Planning & Development Consultants

RESPONSE TO THE SUBMISSION OF SIGNIFICANT FURTHER INFORMATION AS PART OF AN EXISTING THIRD PARTY PLANNING OBJECTION IN RESPECT OF A PLANNING APPLICATION IN THE AREA OF DUBLIN CITY COUNCIL, REG. REF. 2683/21. THE DEVELOPMENT CONSISTS OF THE CO PERMISSION FOR DEVELOPMENT AT A SITE (C.039HA) AT GLENAVON HOUSE, 46 BALLYMUN ROAD, GLASNEVIN, DUBLIN 9. THE SUBJECT SITE IS GENERALLY BOUNDED TO THE WEST BY BALLYMUN ROAD AND CLONMORE COURT APARTMENTS, TO THE NORTH BY GLENAVON COURT AND HILLCREST COURT APARTMENTS, TO THE EAST BY THE REAR GARDENS OF HOUSES ON ST. MOBHI ROAD, AND TO THE SOUTH BY MOBHI COURT APARTMENTS AND HOUSES AT THE HAVEN. THE DEVELOPMENT WILL CONSIST OF THE CONSTRUCTION OF A 5 TO 6 STOREY APARTMENT BUILDING (TOTAL GFA C.5,330 SQM EXCLUDING CAR PARK), PARTIALLY OVER BASEMENT, ACCOMMODATING 52 NO. RESIDENTIAL UNITS (13 NO. 1-BED APARTMENTS, 9 NO. 2-BED APARTMENTS, 17 NO. 2-BED DUPLEX APARTMENTS, 8 NO. 3-BED APARTMENTS AND 5 NO. 3-BED DUPLEX APARTMENTS), ALL WITH PRIVATE BALCONIES ON THE EAST OR WEST ELEVATION (ETC). 1 NO. CAR SHARE SPACE AT SURFACE LEVEL. 37 NO. CAR PARKING SPACES AT BASEMENT. 80 NO. BICYCLE PARKING SPACES. ESB SUBSTATION A

Fig. 4: Original east elevation of block which faced client properties on St. Mobhi Road & their rear gardens

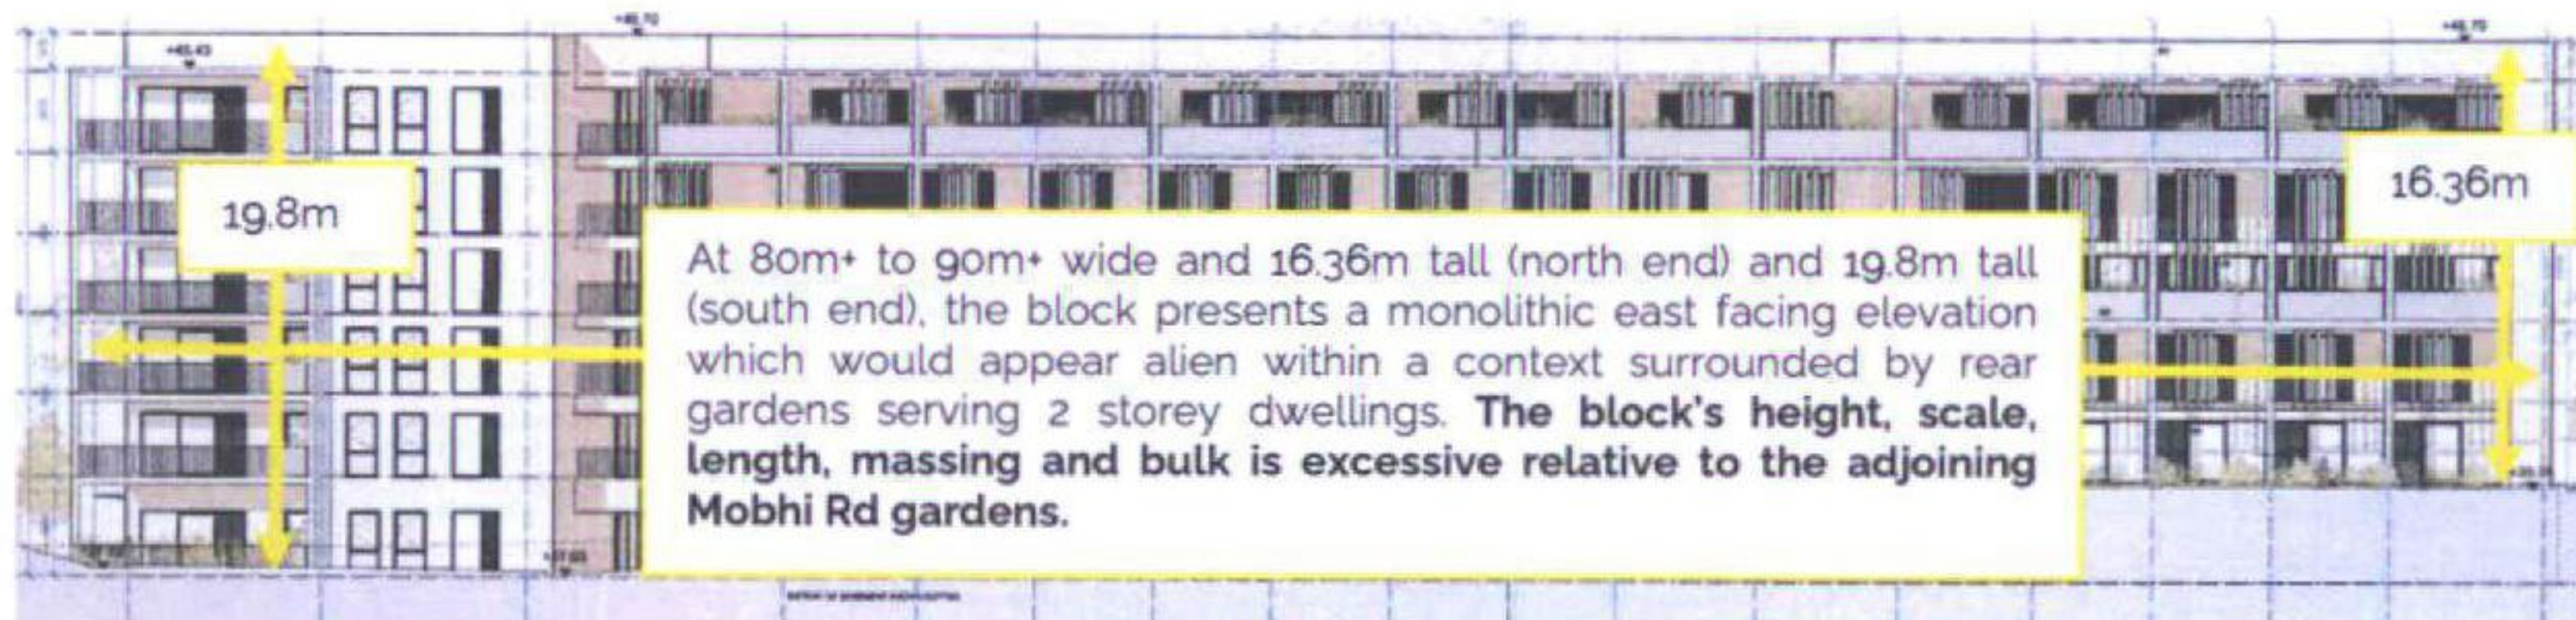
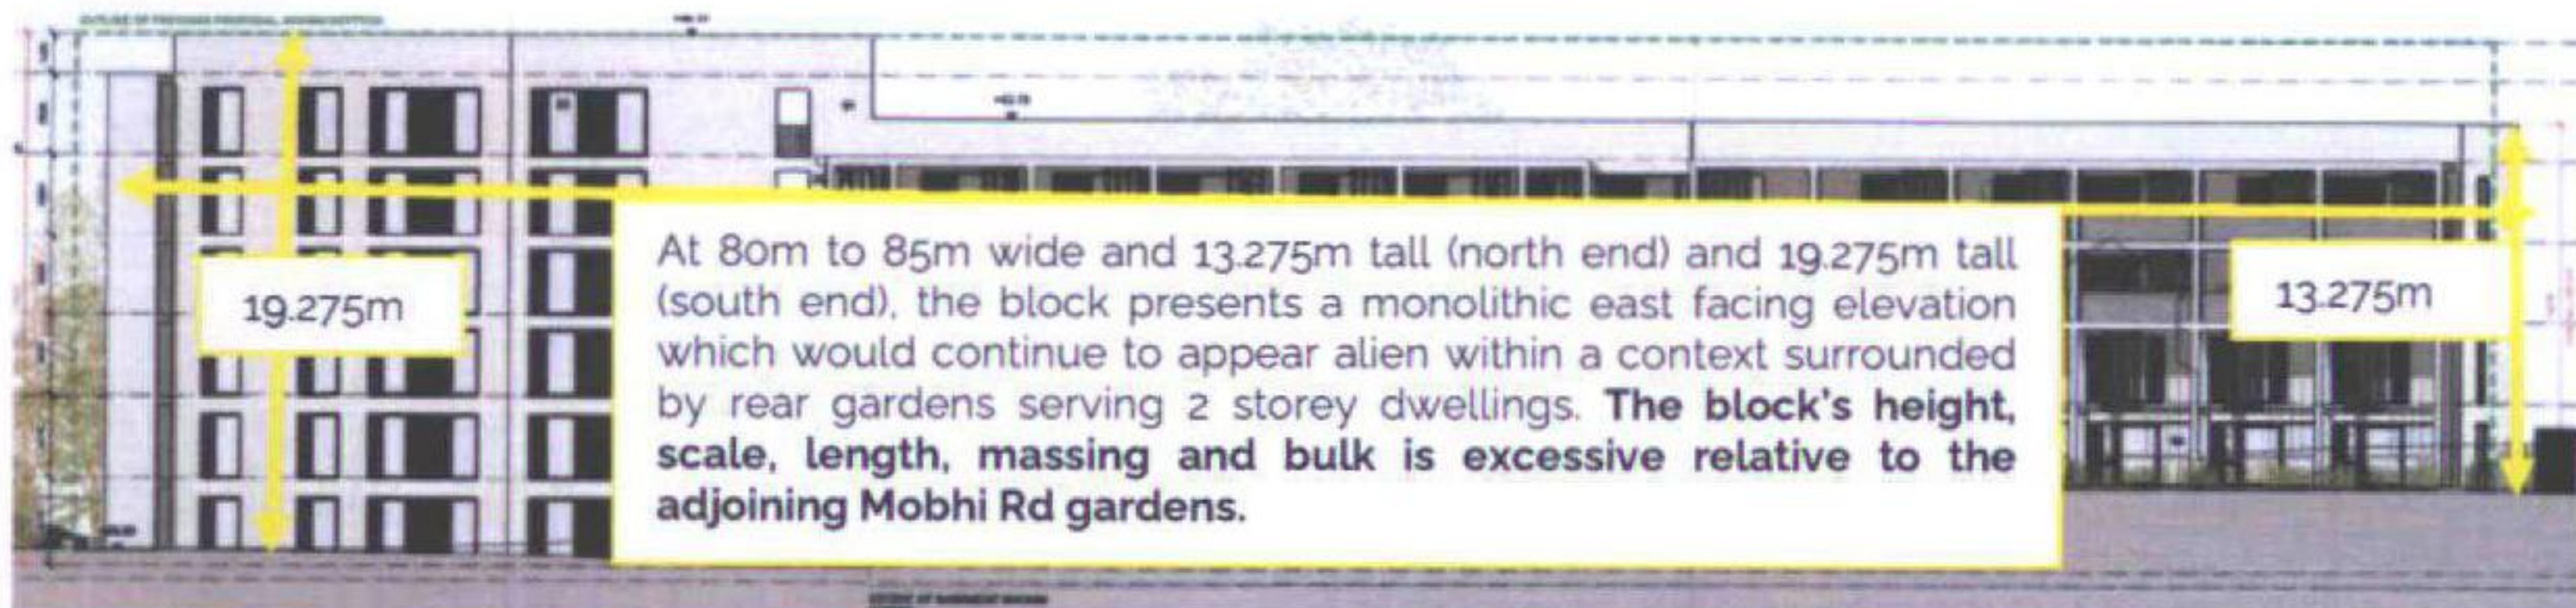
Note: Block C is 6 storeys and Block B is part 4 and part 5 storeys. The Applicant floor plans give the misleading impression the building is 4 and 5 storeys. Care is required given the differing ground levels to our clients properties.

Our clients have reviewed the Applicant's SFI submission's drawings, cross sections, and floor plans (see Figs. 4 to 15). The primary change offered by the Applicant is the reduction in the height of the parts of the single block they refer to as Blocks A and B from

Fig. 12: Original and SFI setbacks to client properties on St. Mobhi Road & their rear gardens

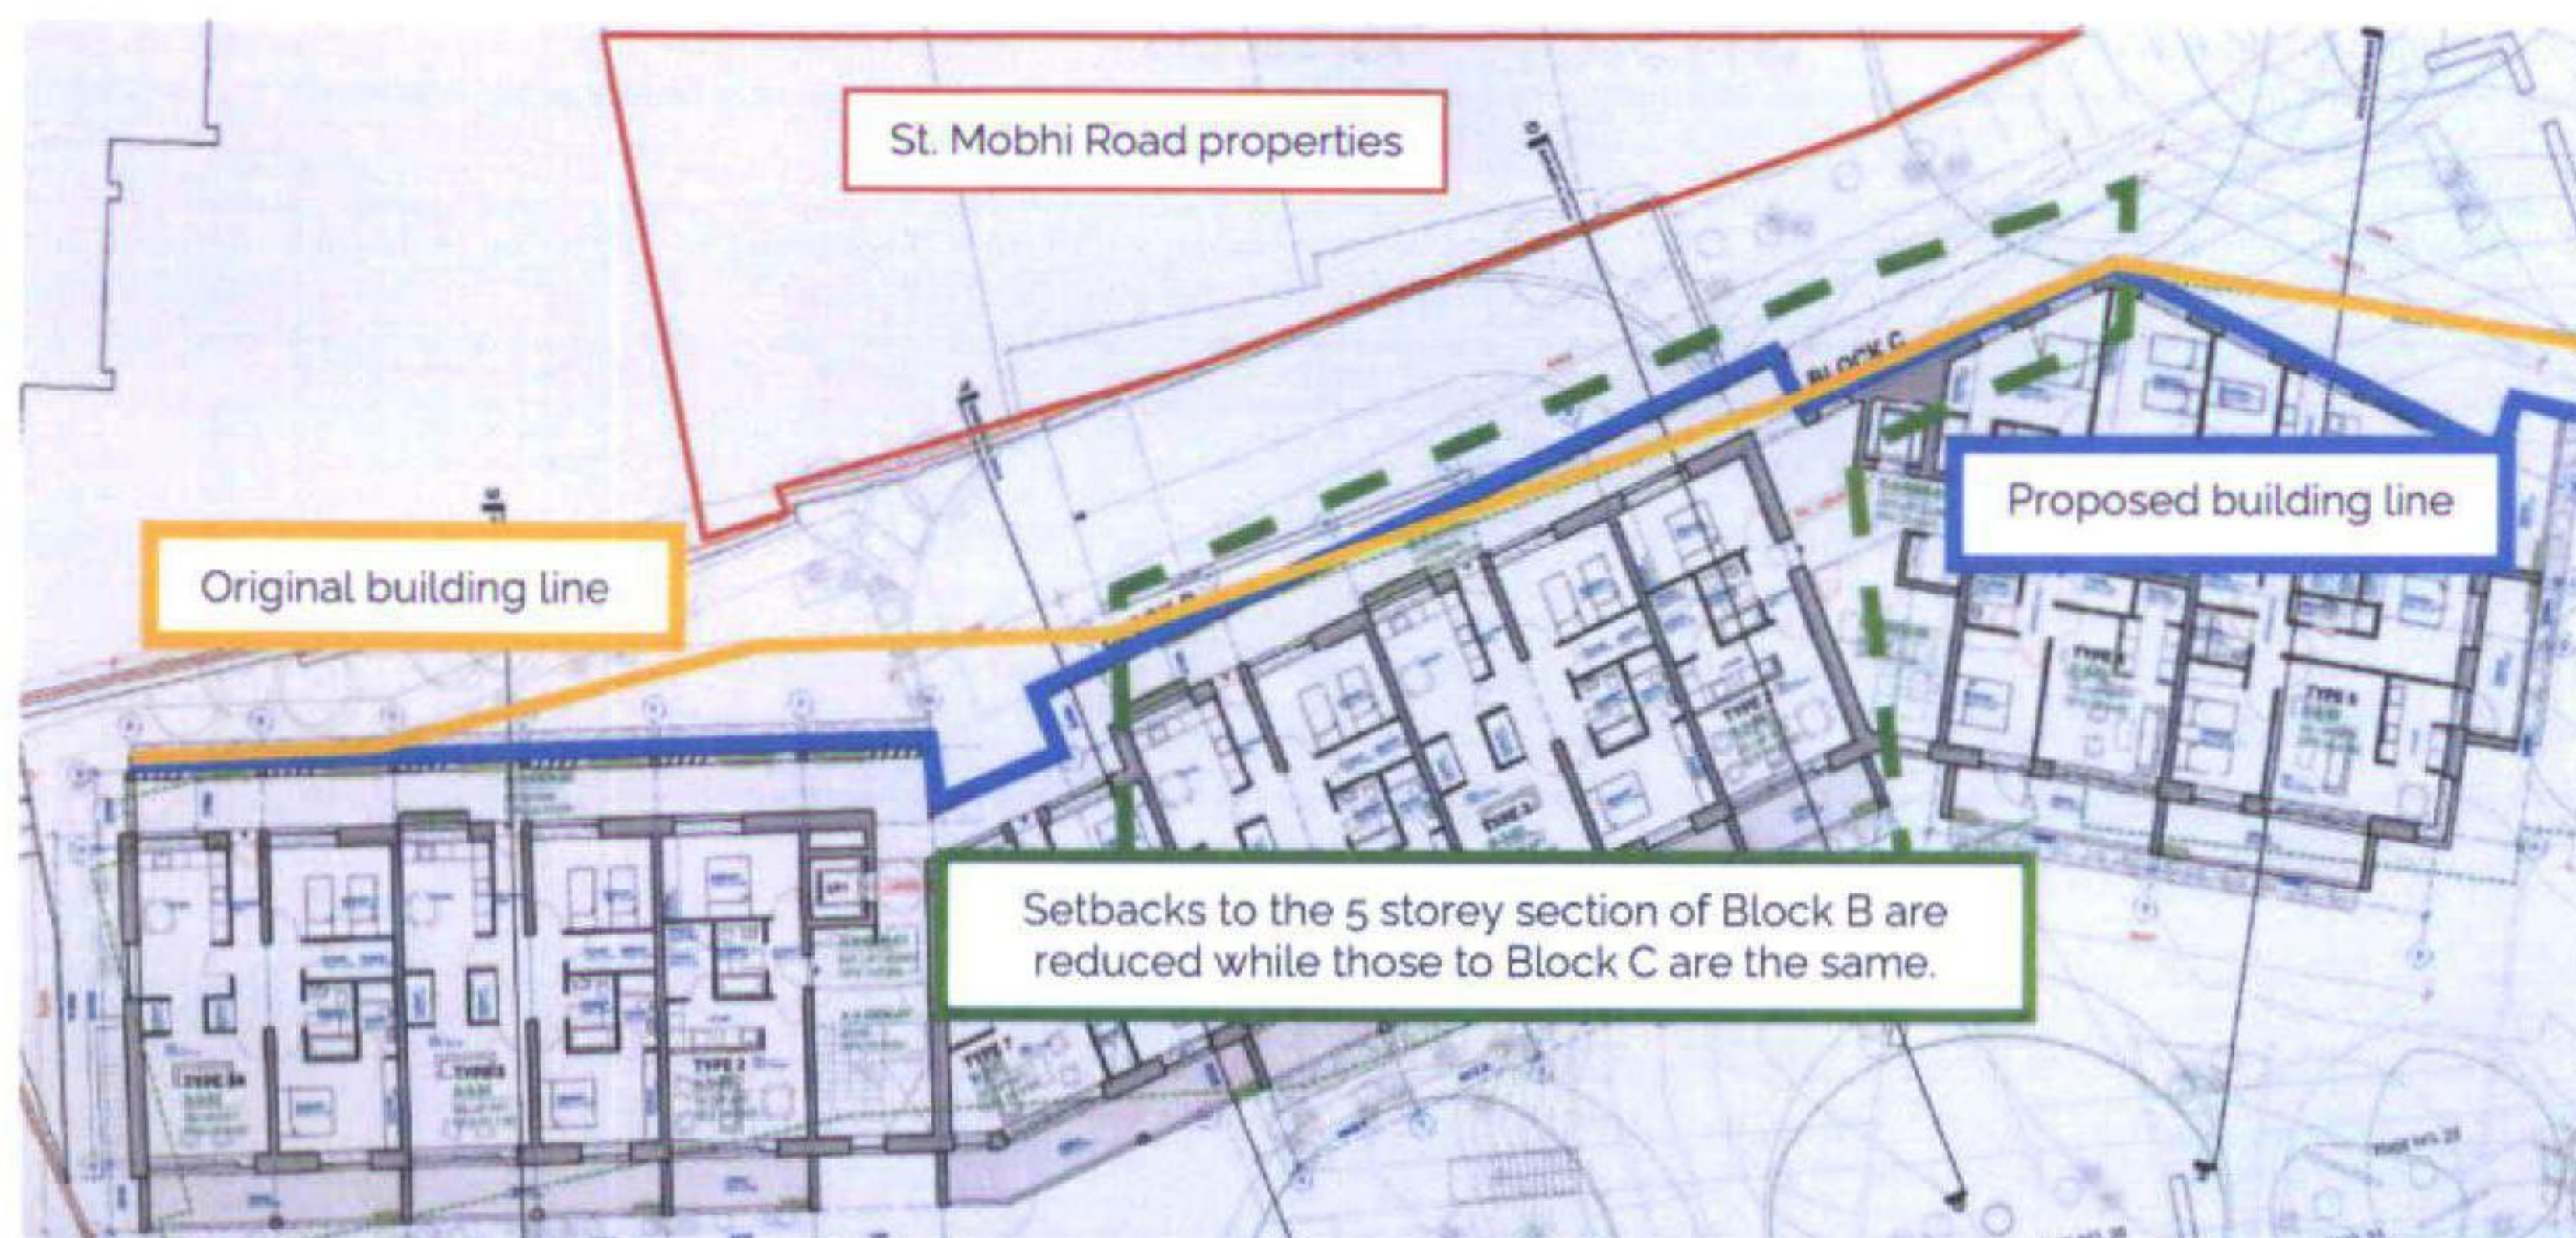
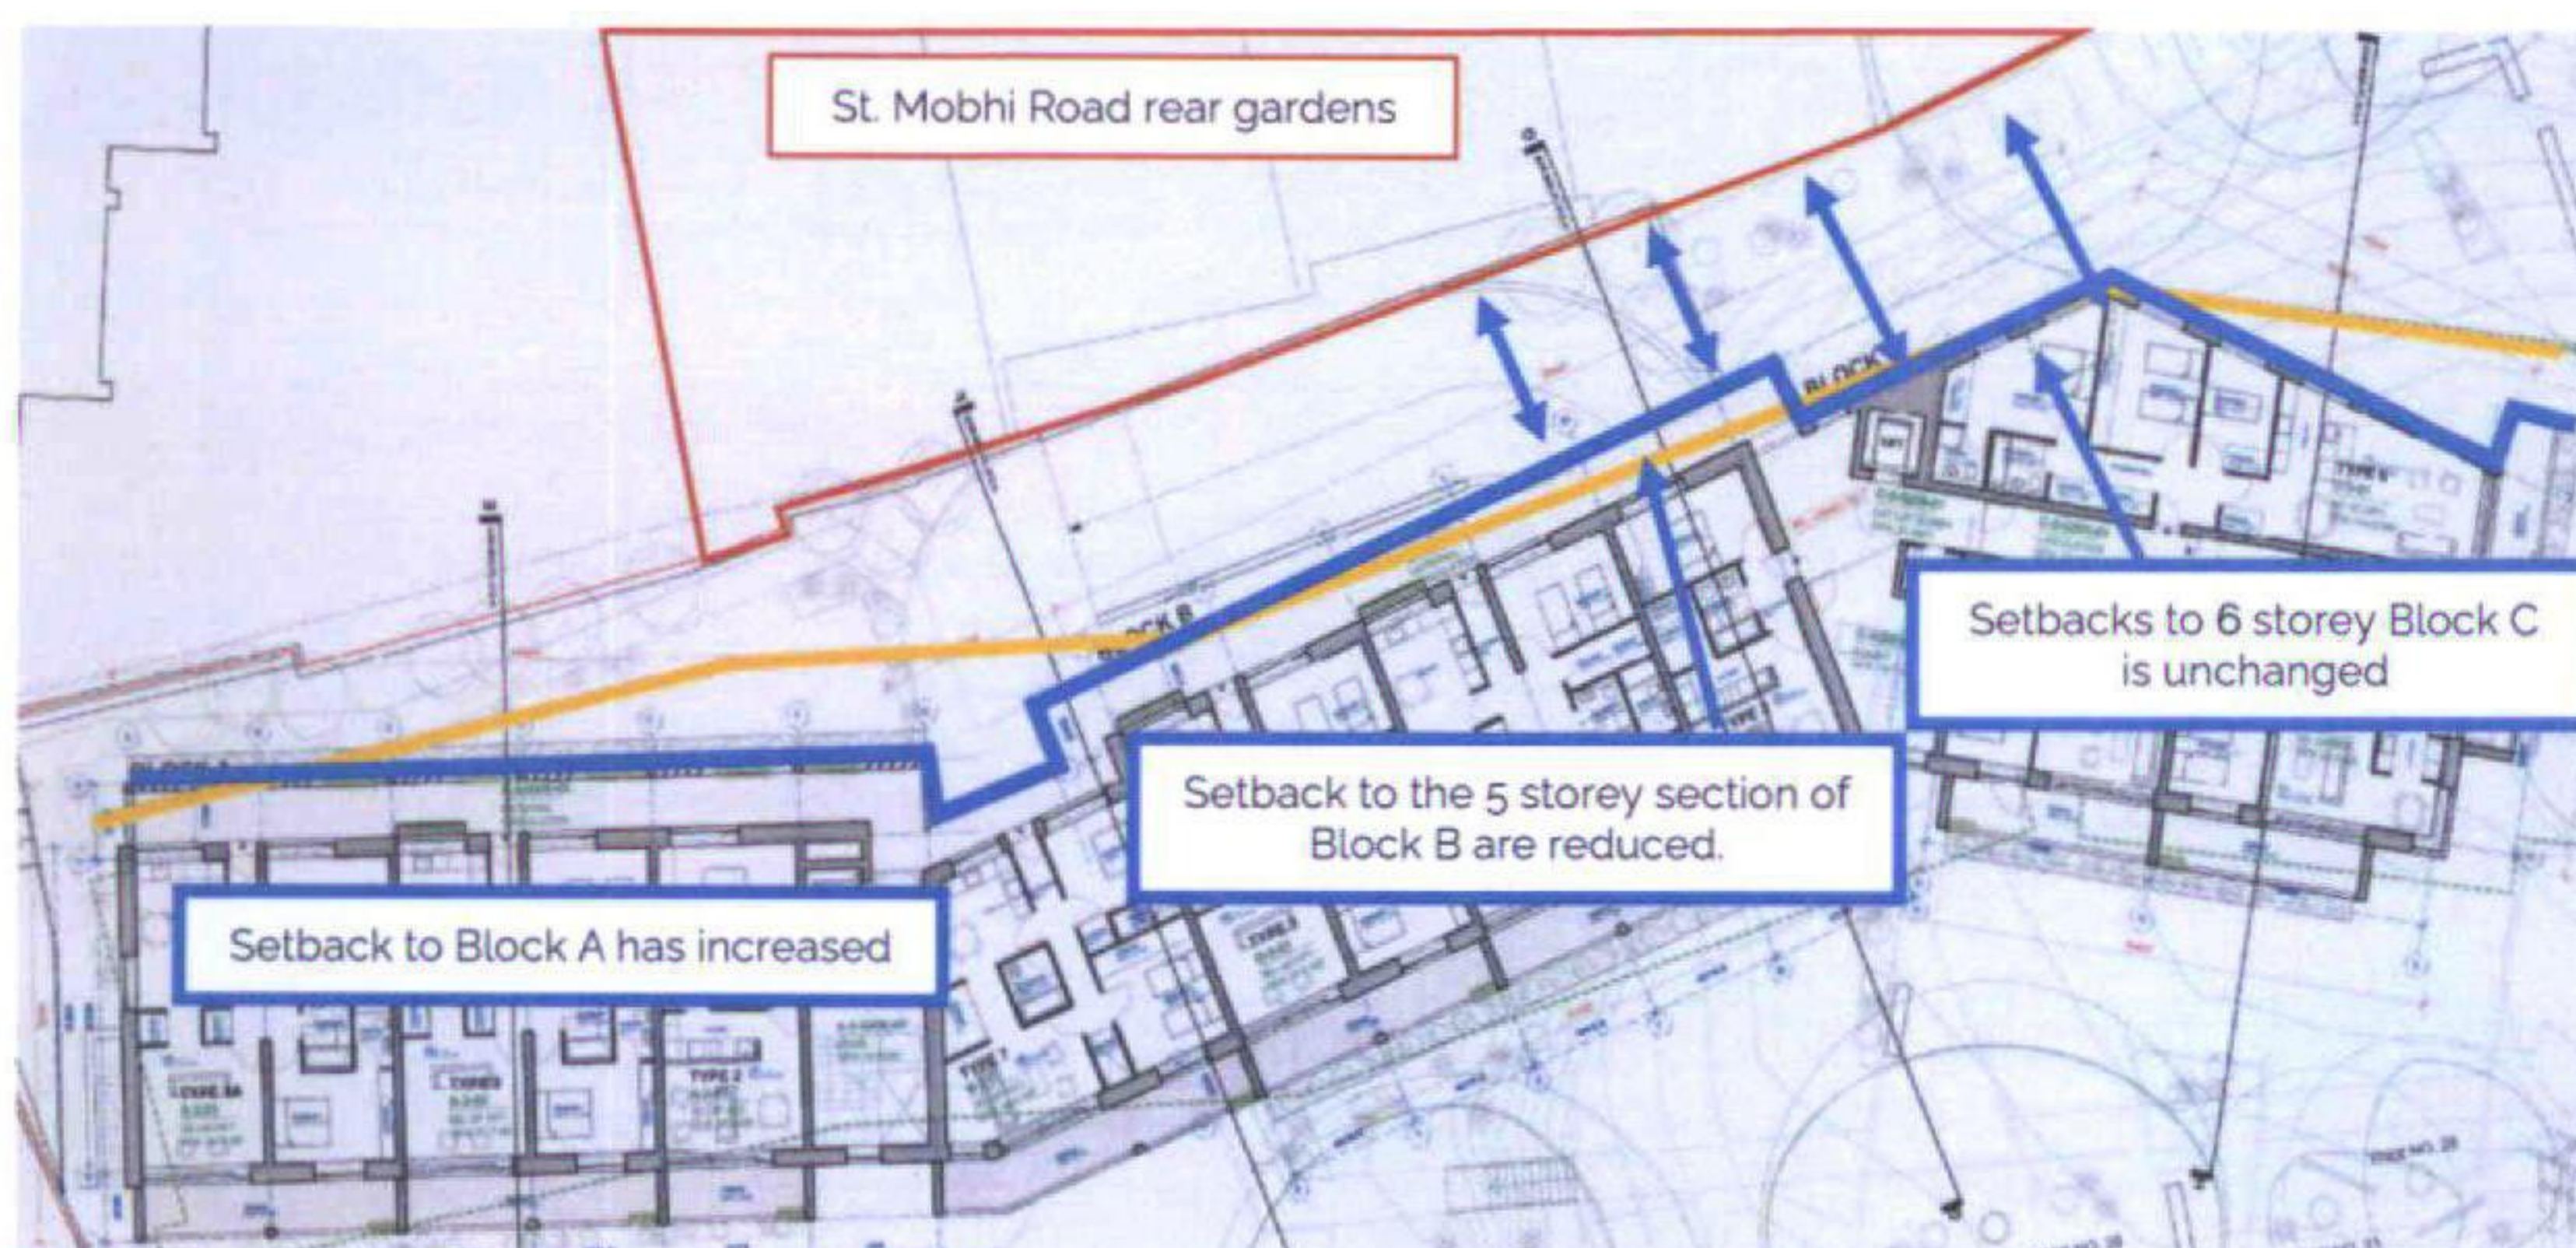
2. **Claims to provide greater separation distances to the eastern boundary require review.** The Applicant repeats the claim that the building is setback further in the SFI scheme than it was originally. Figs. 12 and 13 of this letter show that this is not the case for Blocks B and C. Blocks B and C are closer or setback to the same extent as they were originally. Block B remains partly a 5 story building while Block C remains a fully 6 storey building.
3. **No additional mitigation and/or screening measures are introduced to address significant overlooking arising.** Our clients' concerns as to direct overlooking from Blocks A, B and C are not addressed. Concerns over the perception of overlooking are not addressed and the measures that purportedly offer screening to mitigate overlooking serve to increase the bulk of the building as it faces our clients' properties.
